City of Mississauga Department Comments

Date Finalized: 2022-08-31 File(s): A408.22
Ward: 1

Property Address: 2105 Stanfield Rd

Appendix 1 – Transportation and Works Comments

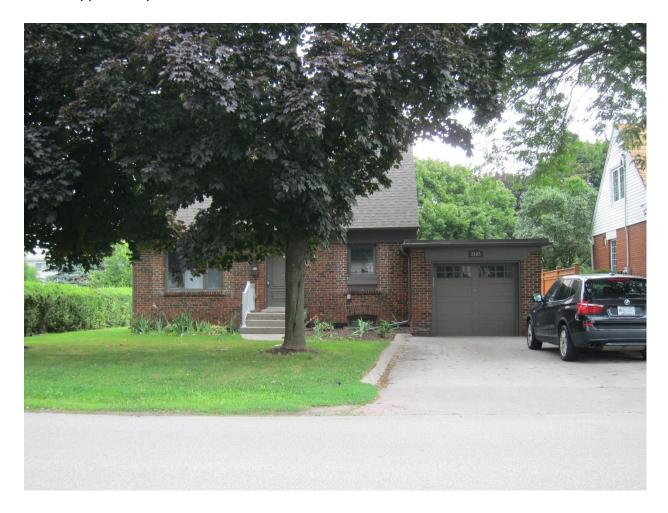
We are noting for Committee's information that any Transportation and Works Department concerns/requirements for the proposed addition will be addressed through the future Building Permit Application process.
